Product Alert for Yokogawa Process Analyzers Europe BV Inductive Conductivity Sensors

June 11th, 2024

Subject: **Announcement of ISC40S nonconformity**

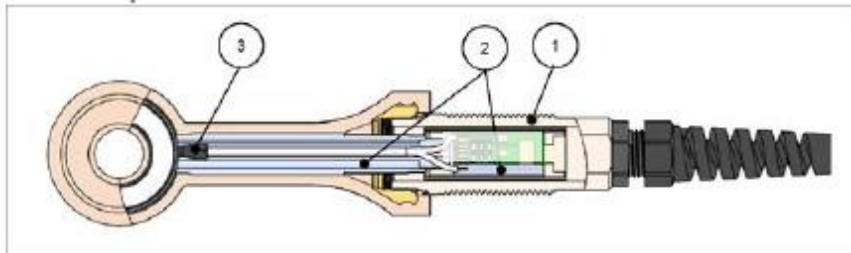
We have found a possible safety issue that needs improvement. An investigation of the ISC40S conductivity sensor has revealed a deviation from the approved EX-product design requirements for this sensor model. The ISC40S conductivity sensor is classified for use in hazardous Zone 0 areas with temperature classes T4-T6. The Pt1000 temperature element is insufficiently encapsulated to meet thermal protection requirements on self-heating for Ex products.

Pos. 1: Stainless Steel screw part for process connection.

Pos. 2: Casting compound

Pos. 3: Temperature sensor
